Re: Public Health Assessment (Public Comment Release), Pagel's
Pit Landfill, New Milford, Winnebago County, Illinois,
CERCLIS No. ILD980606685

**Comments on
Public Health Assessment
Pagel's Pit Landfill
Public Comment Release**

Appendix C
Map of the Site

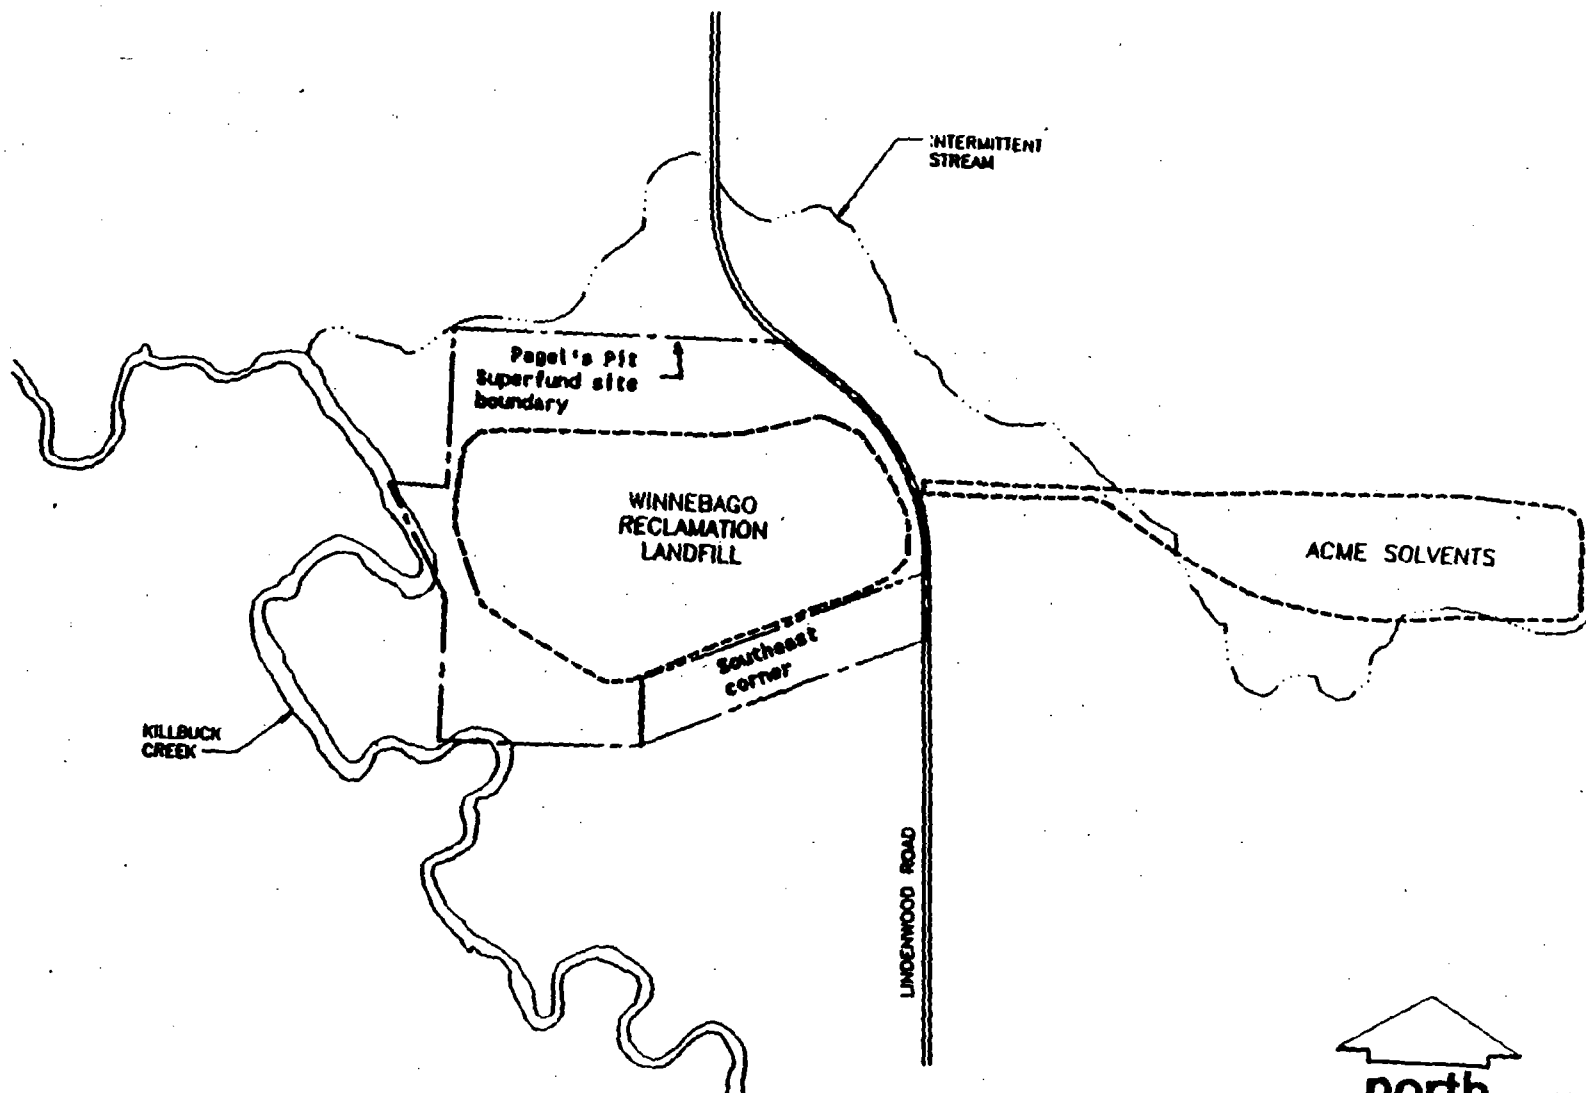
Attached is a copy of the "Map of the Site" which is Appendix C of the Consent Decree entered February 11, 1993. In the definitions section of the Consent Decree, "Site" is defined as "the Pagel's Pit Landfill Superfund site, encompassing approximately 90 acres, located on Lindenwood Road, south of Baxter Road (also known as the Winnebago Reclamation Landfill) in Winnebago County, Illinois and depicted generally on the map attached as Appendix C."
